**APPLICATION AS NOTIFIED**

**(RM210657)**

### **SERVICE OF NOTICE / LIMITED NOTIFICATION**

**RM210657 – REQUEST FOR FURTHER INFORMATION RESPONSE**

ELEVATIONS. 1:100.

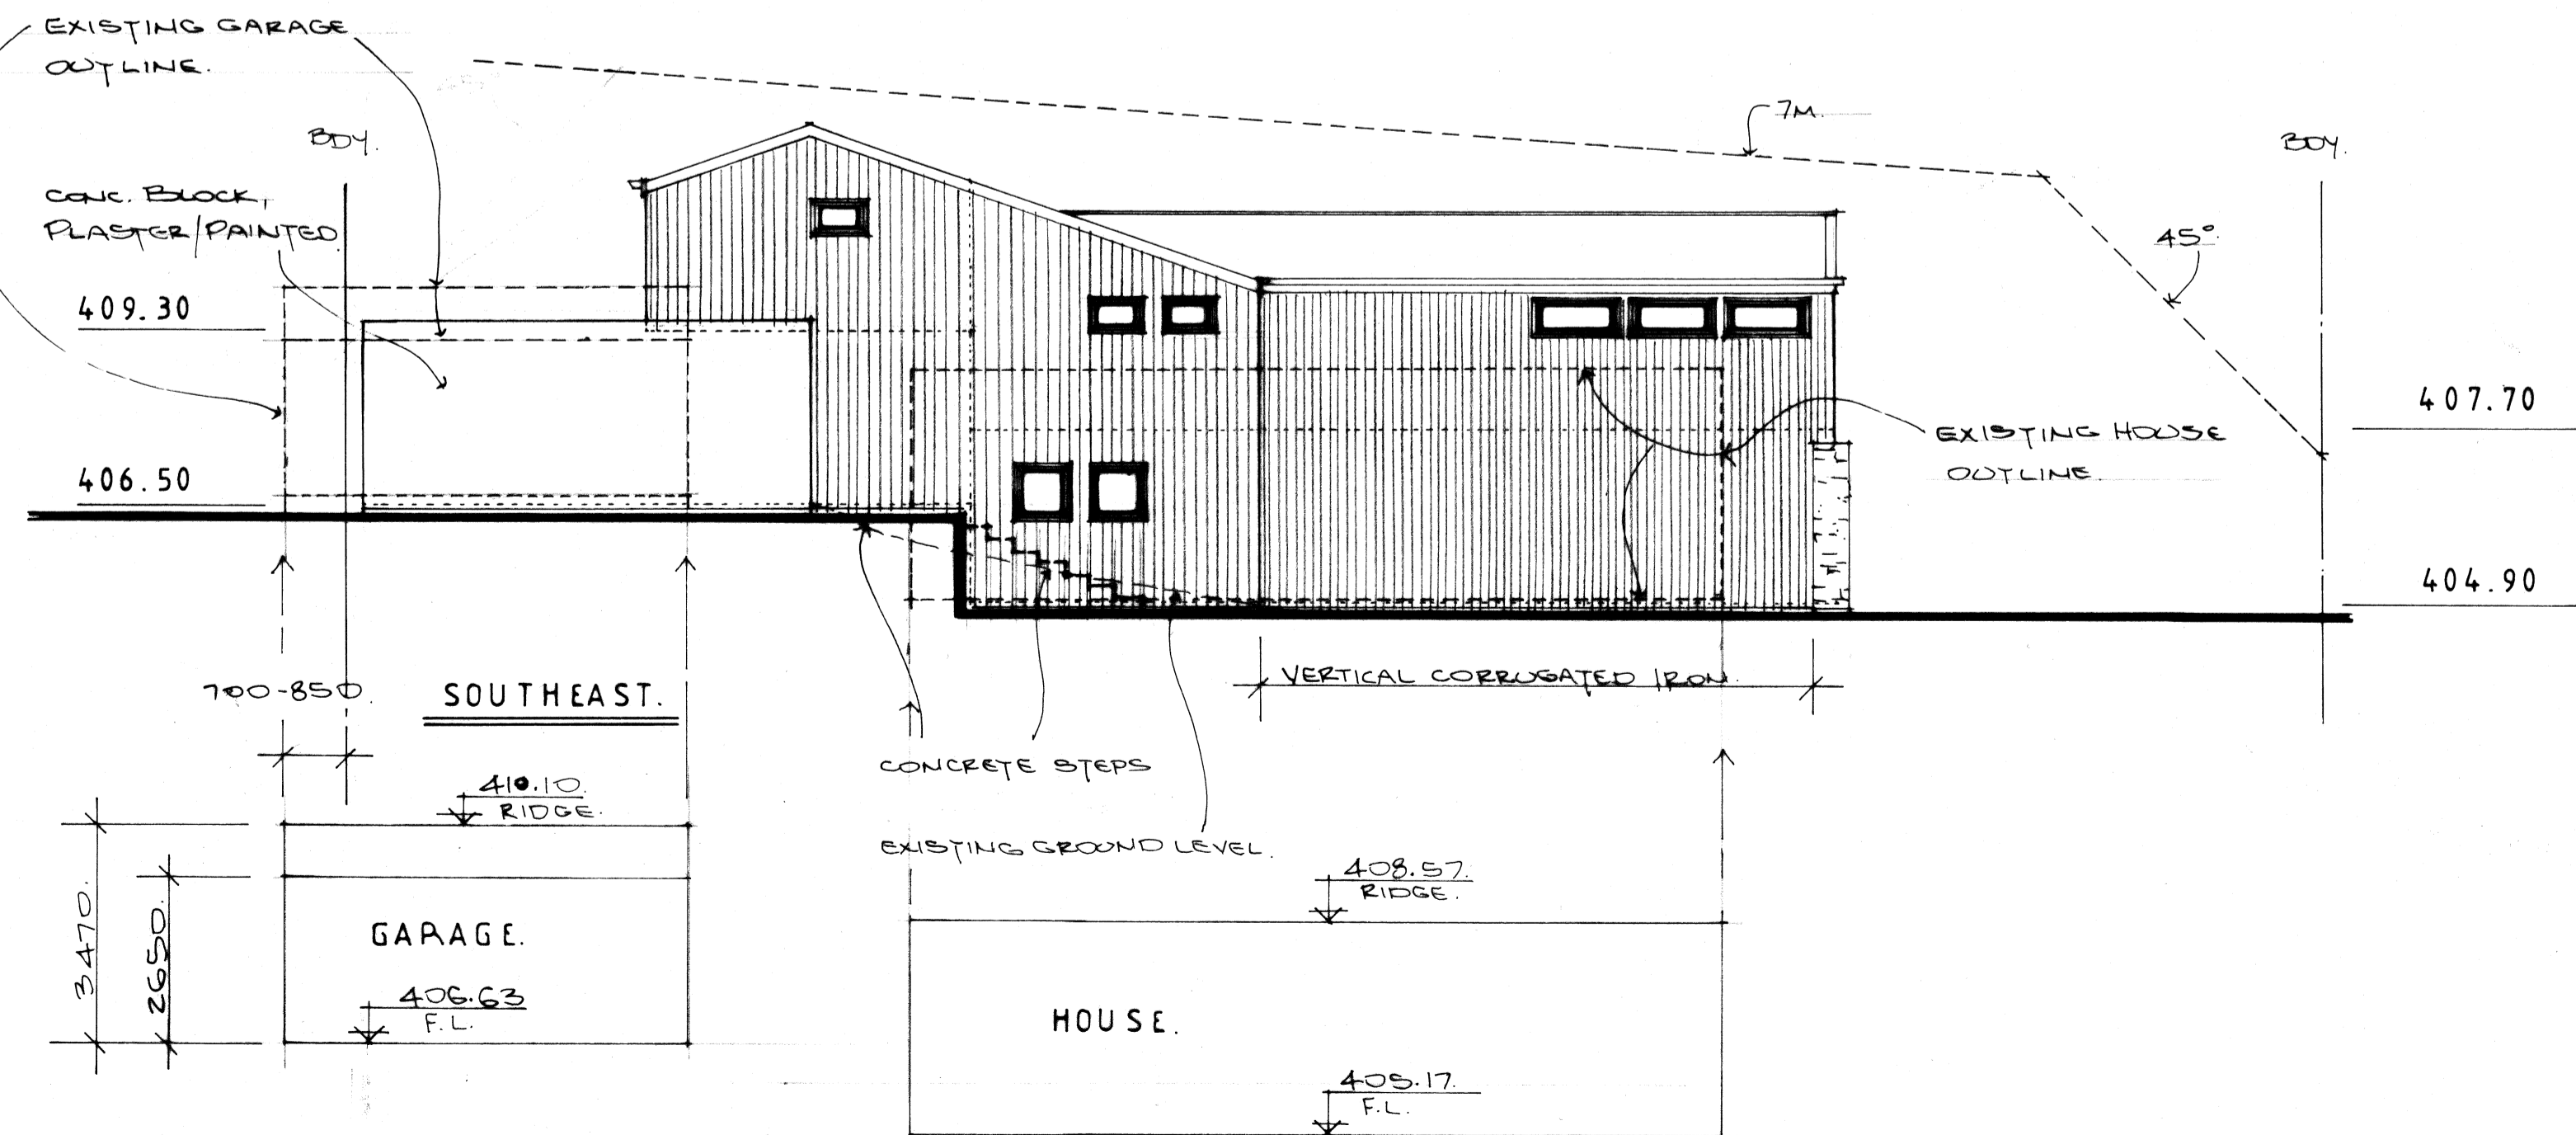
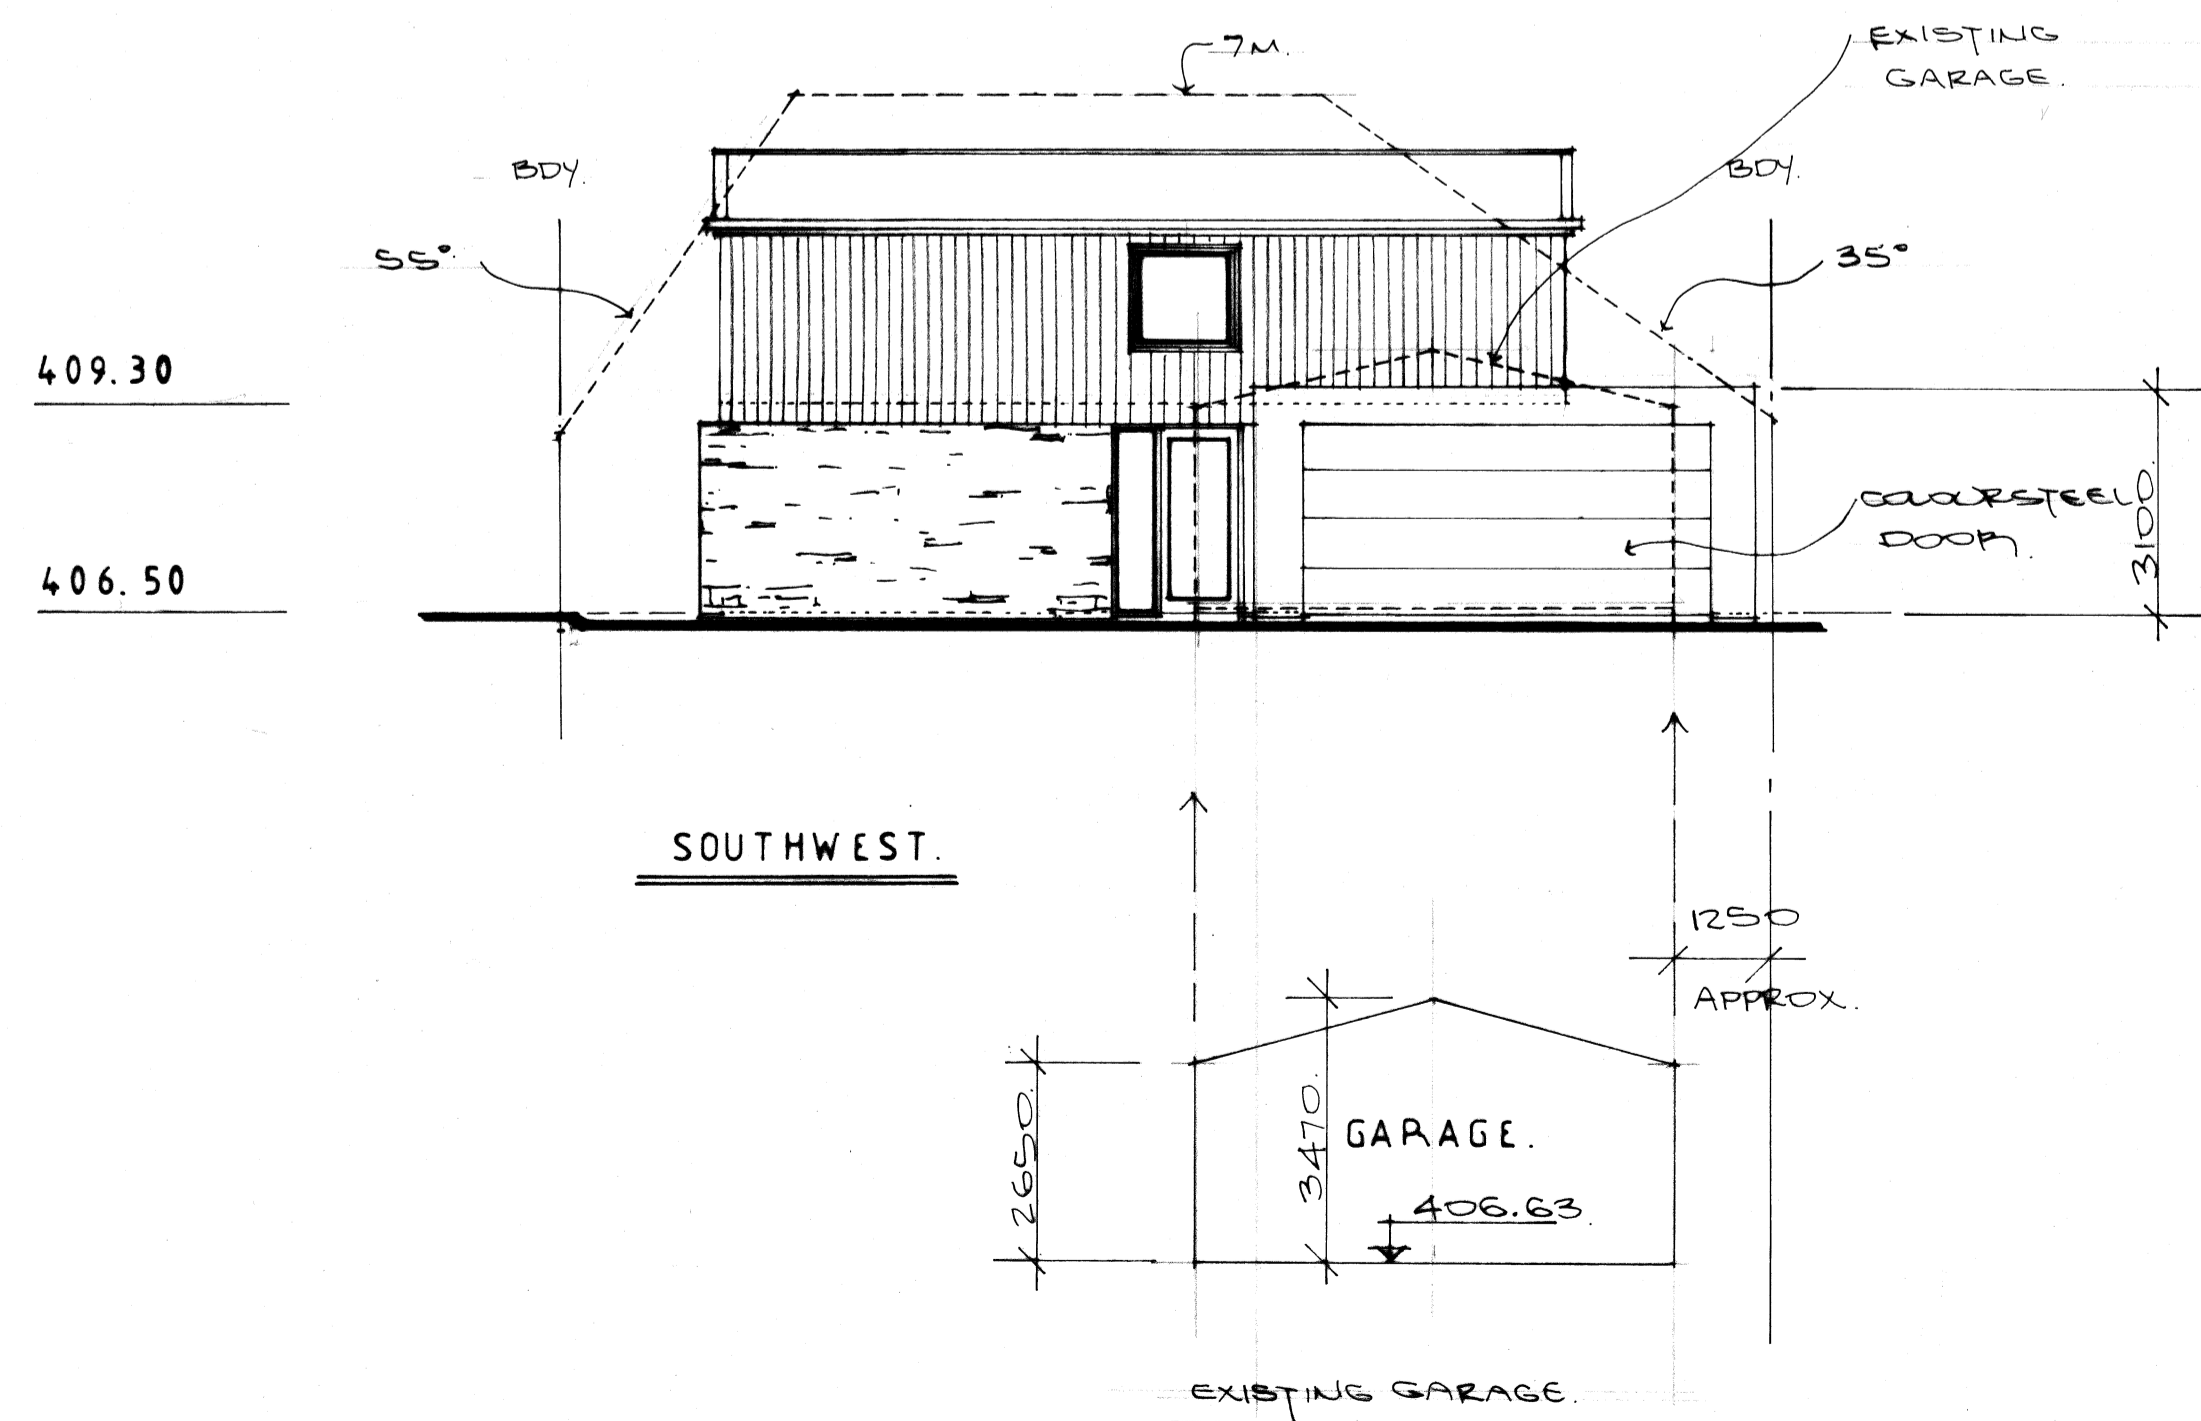
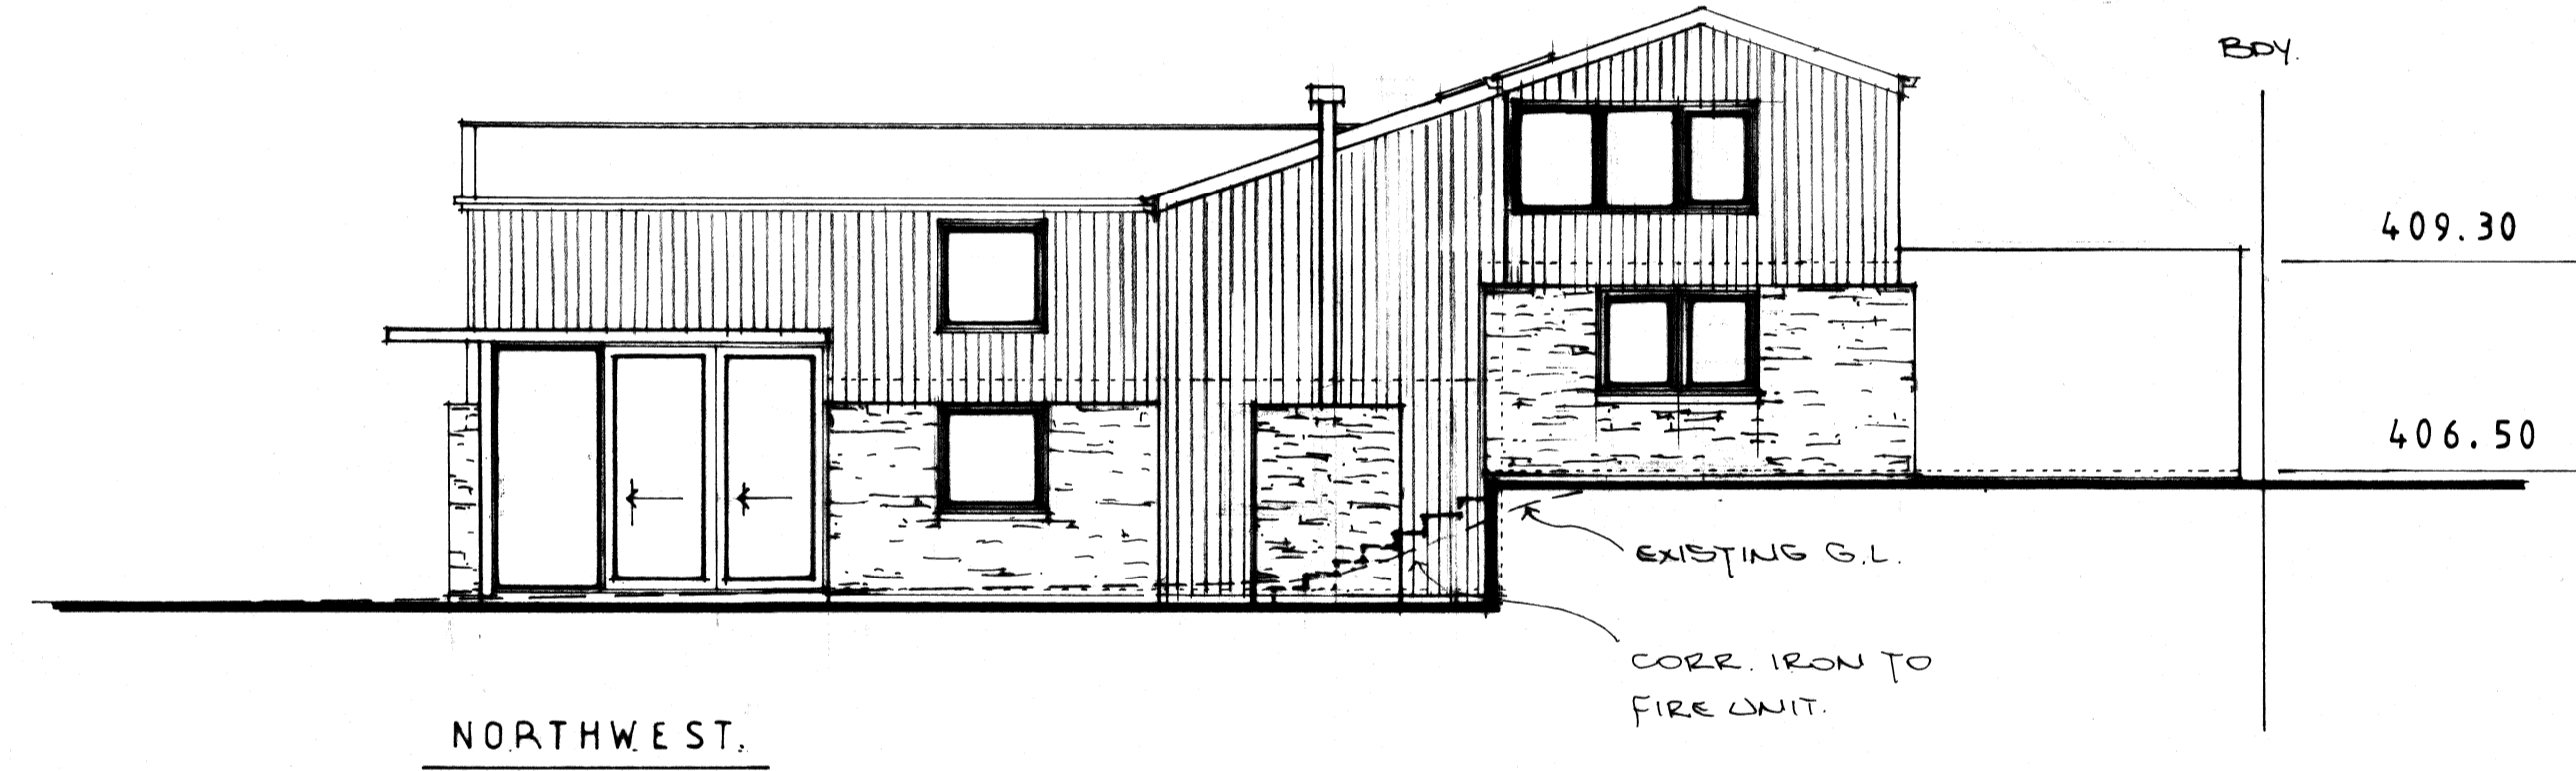
4. In order to fully assess the effects of the height in relation to boundary infringements, could you please provide amended versions of the south eastern and north western elevations on sheet A1-03 showing the extent of the height plane angle infringements that run along the length of the dwelling (shown in blue on the Aurum Survey plan but not on the architectural plans).

4. In order to fully assess the effects of the height in relation to boundary infringements, could you please provide amended versions of the south eastern and north western elevations on sheet A1-03 showing the extent of the height plane angle infringements that run along the length of the dwelling (shown in blue on the Aurum Survey plan but not on the architectural plans).

See attached plans.

From the northwest elevation (adjacent to 5 Devon Street), the maximum breach of the infringement is 1.2 metres. The recession plane breach extends along the length of the building by approximately 6.9 metres with the majority of this breach under 1 metre in height (with the exception of the breach at the gable). The boundary between 5 and 7 Devon Street is 31.78 metres. Taking into consideration the length of this boundary and the overall scale of the recession plane breach, it is assessed potential effects relating to dominance and loss of amenity will be less than minor.

From the southwest elevation (adjacent to 9 Devon Street), the maximum breach of the recession plane breach is 1.6 metres at the southern gable. The recession plane breach continues the length of the building and breaches by a maximum of 700mm along the northern half of the building. The residential unit (excluding the garage) has a total length of 19 metres adjacent to 9 Devon Street. The total length of the boundary here is also 31.78 metres. Effects relating to the recession plane breach are mitigated by the bulk of the building being set back 2.5 metres from the boundary, as opposed to the permitted 1.5 metres. This will create a sense of openness and space between the two sites. In addition, a large area of the northern part of the site will remain vacant of built form. This will allow appropriate solar access to be retained at 9 Devon Street. The area that is free of built form on the subject site will also contribute positively to the overall amenity for the owners and occupiers of 9 Devon Street. Containing the recession plane breach within the southern portion of the site is considered to appropriately mitigate potential adverse residential amenity effects. A much longer building, closer to the boundary could be constructed alongside this boundary. While such building would be slightly lower in height to meet recession plane requirements, having a building constructed along the length of the boundary, at a distance of 1.5 metres from this boundary, would likely impact the owners of 9 Devon Street in a more significant way than the current design. It is assessed that this setback, along with the open space at the northern portion of the site, is sufficient to mitigate the recession plane breach.
